REQUEST FOR PROPOSAL - ADDENDUM 1
Question & Answer

Applicant	**Killeen Independent School District**
BEN	**141065**
Form 470 #	**270002748**
470 Description	**KISD 2027-C1 WAN**
Addendum #	**1**
Date Posted	**11/23/2026**
e-Bidding Link	https://kellogglc.bonfirehub.com/portal

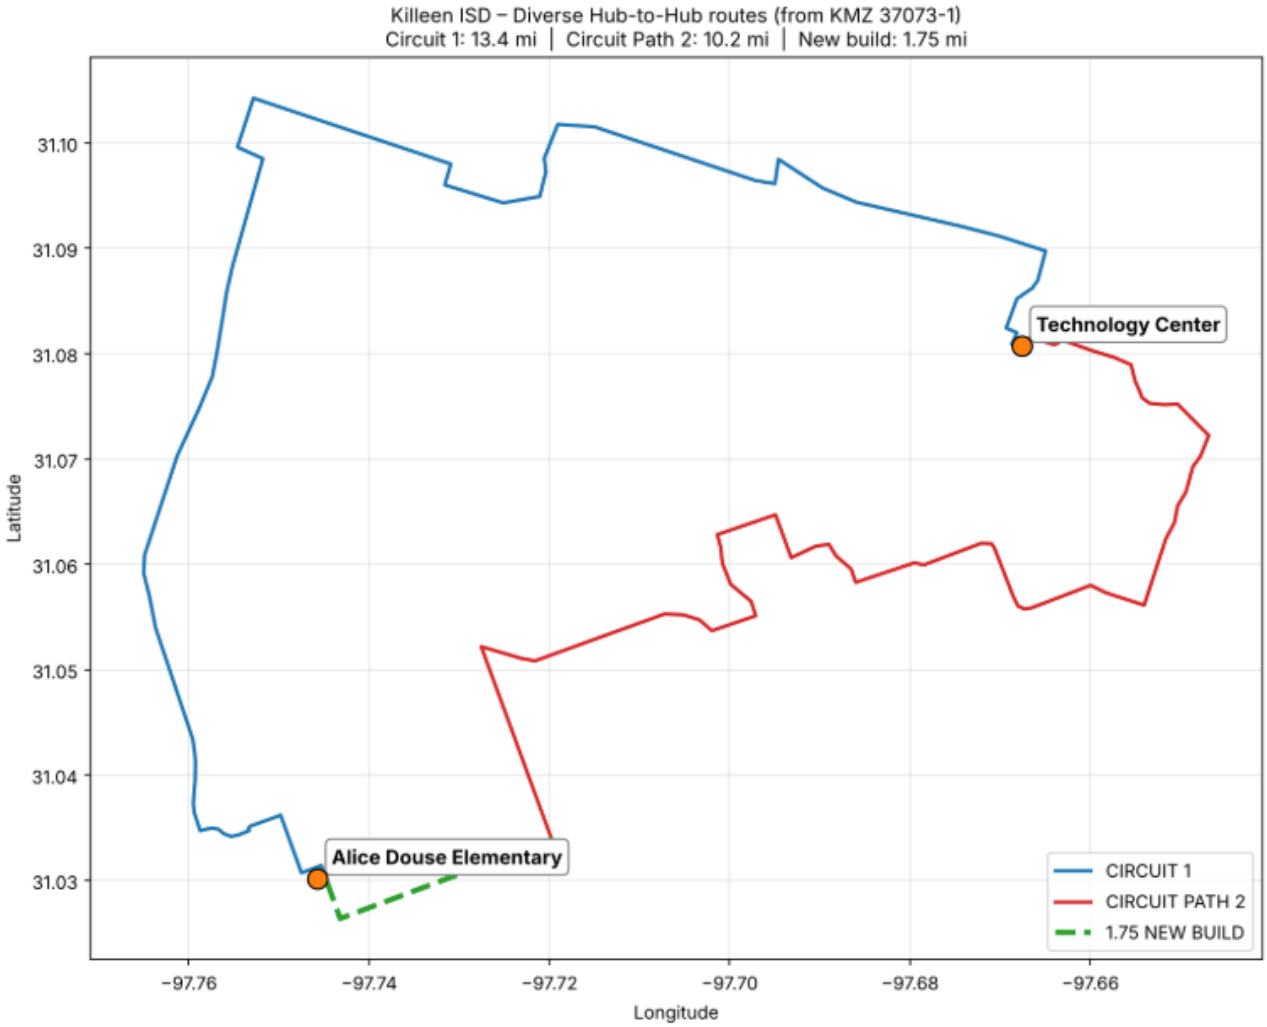
Question: Does it need to come from a different direction?

Question: The RFP requires the proposed 100 Gbps circuit between the Technology Service Center and Alice Douse Elementary School to be physically and geographically diverse from the existing circuit, including no shared fiber, conduit, or pole line. We did not see a KMZ/KML or other GIS file identifying the existing primary route. Would Killeen ISD please provide a KMZ/KML file, or equivalent detailed route information so we can accurately design and validate a fully diverse route?

Answer: Yes. The fiber must come from an alternate path and not use the same path that is currently in use.

Answer: The KMZ file was converted to PDF format and included in the RFP on page 8. Please refer to the diagram below for reference.
